FREDERICK COUNTY PLANNING COMMISSION

TITLE: **Above Air Technology**

FILE NUMBER: **SP 87-12, AP #13287, APFO #13289, FRO #13290**

REQUEST: **Site Plan and APFO Approval**

Graphic #1

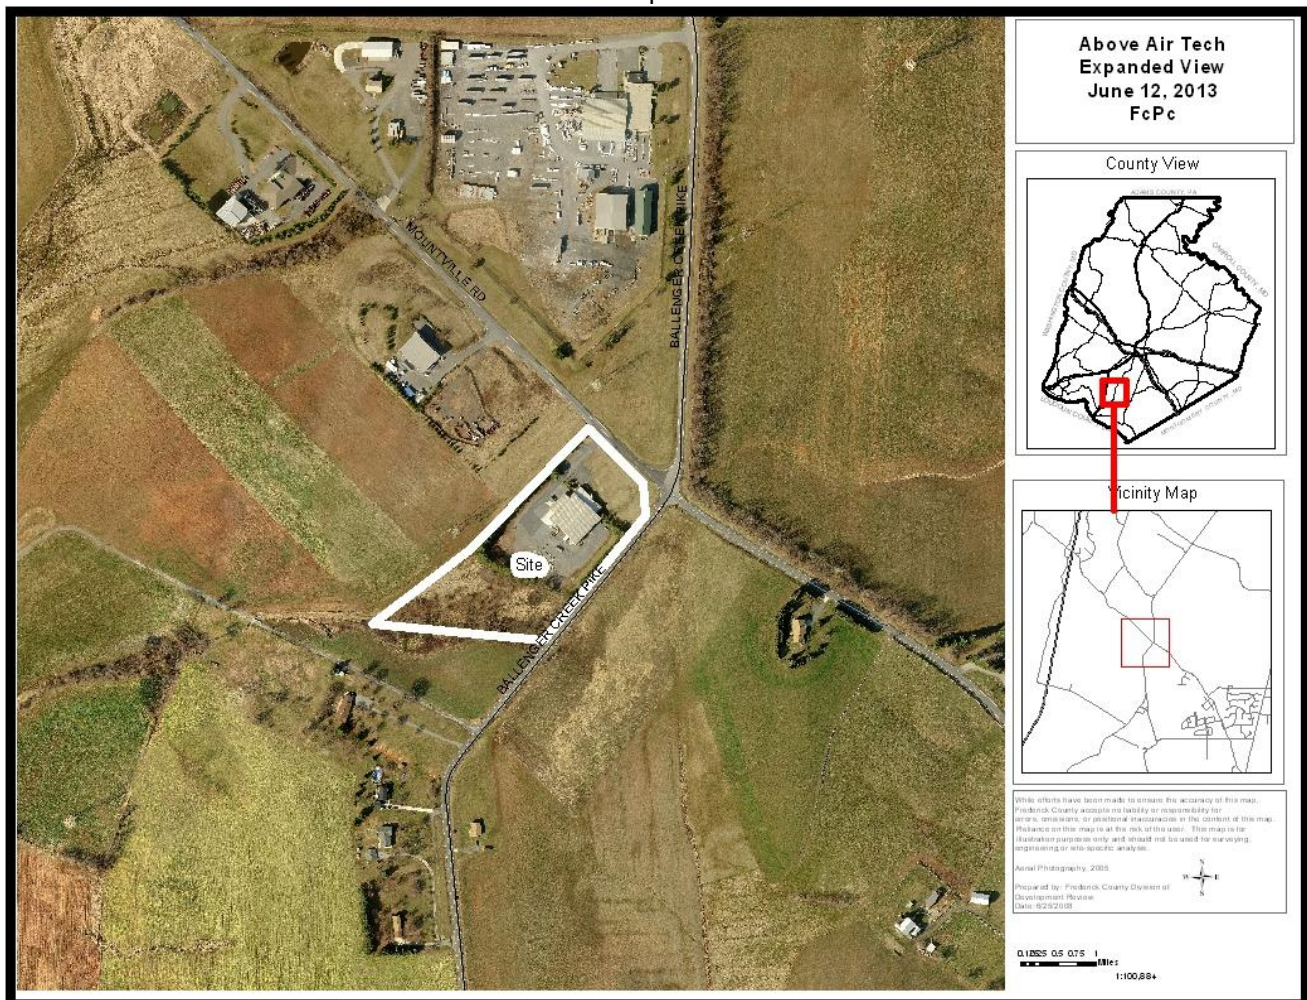
This development proposal will be broken down into two phases; Phase One will consist of three building additions to the existing 19,440 square foot building. The three building additions are as follows; a 55' x 25', 1,375 square foot addition to the north west corner of the building, a 30' x 28', 840 square foot addition to the south east corner of the building, and a 150' x 125', 18,750 square foot addition to the south side of the existing building. Phase One also includes the addition of 11 parking spaces, including 2 ADA handicapped accessible spaces. See Exhibit #1. All of the proposed stormwater management areas will be constructed as part of Phase One. The total additional building square footage for Phase One improvements will be 20,965 square feet for a combined total of 40,405 square feet.

Phase Two is proposed to consist of an additional 20' wide full movement access point onto Ballenger Creek Pike. See Exhibit #1.

Graphic #2

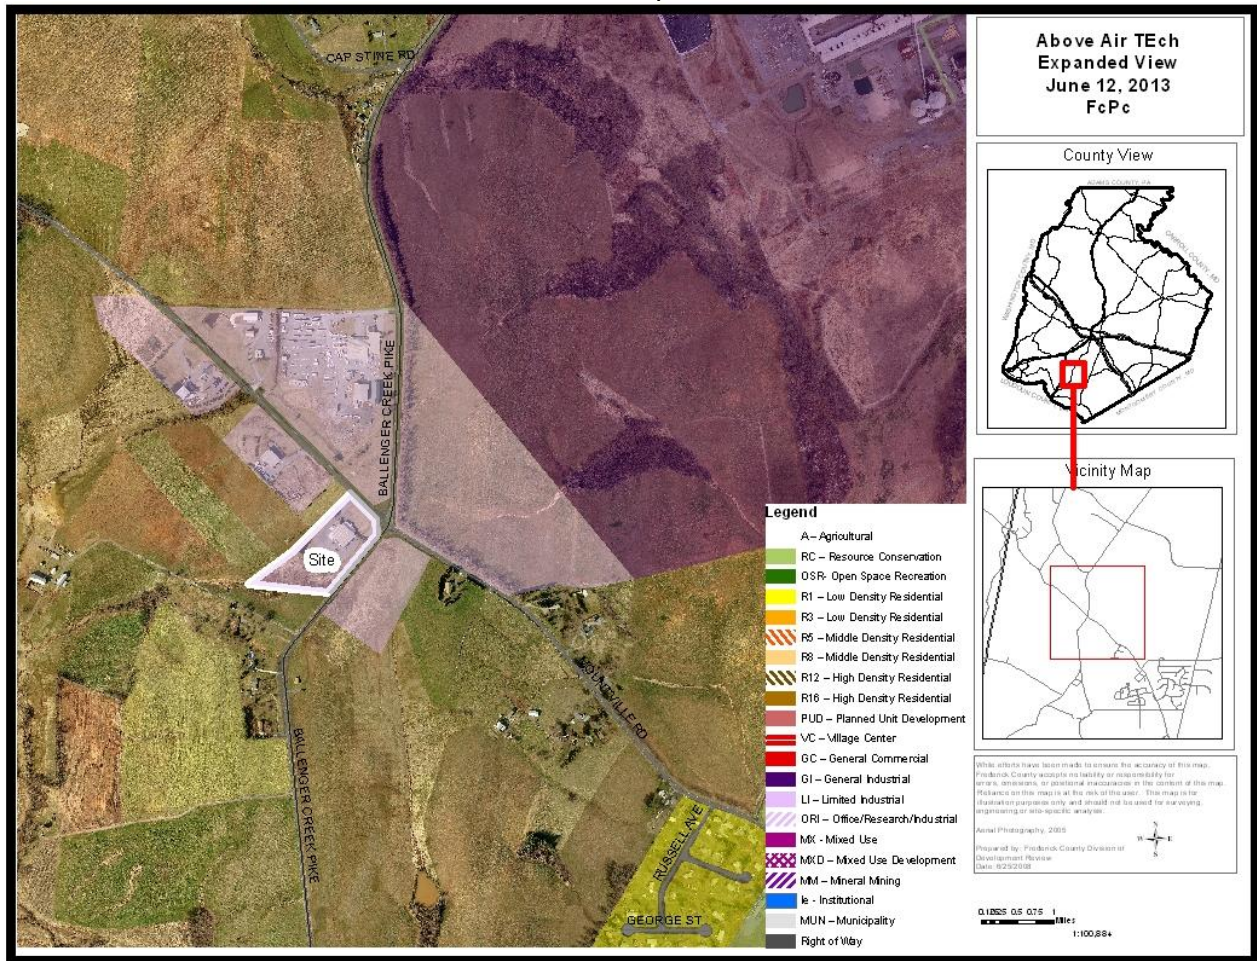
The site is currently zoned Limited Industrial (LI), and is developed with a 19,440 square foot building with 22 parking spaces, see Graphic #2 below. The property to the north of the site is developed with East Alco, the properties to the west are developed with similar industrial uses, lands to the east and south are zoned agricultural and contain single family dwellings or farmsteads.
